Intel[®] 82371EB (PIIX4E)

Specification Update

December 1999

Order Number: [290635-008](#)

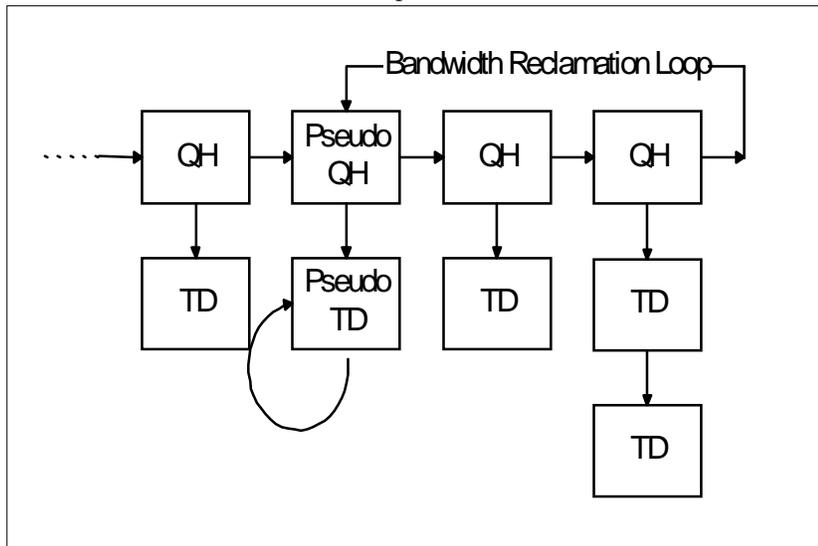
4. USB Bandwidth Reclamation Errata

Problem: This errata affects data transfers in conjunction with a UHCI driver utilizing bandwidth reclamation. In a data structure which implements bandwidth reclamation, when all the queue heads have their terminate bit set (empty QH's), the USB subsystem will be unable to read a new frame pointer and will continuously loop through the bandwidth reclamation queue heads. The effect of the errata is that the USB subsystem will continue to send out Start Of Frame packets but transfer no data. On the PCI bus the PIIX4 will continuously read the queue heads within the bandwidth reclamation loop. For additional information on PIIX4 host controller operation refer to the Universal Host Controller Interface (UHCI) Design Guide (order number 297650).

Workaround: When using bandwidth reclamation, the UHCI driver should insert a pseudo queue head with a pseudo transfer descriptor within the bandwidth reclamation loop. The PIIX4 will fetch this queue head and transfer descriptor on every frame, but will not transfer any data and will never be terminated. The following bits must be properly set to implement the workaround:

QUEUE HEAD LINK POINTER (DWORD 0: 00-03h)

The Queue Head Link Pointer (QHLP=bits [31:4]) must be set to point to the pseudo TD.

The QH/TD Select (Q=bit 1) must be set to 1 indicating it is a QH.

The Terminate bit (T=bit 0) must be set to 0 indicating that the link pointer field points to a valid TD.
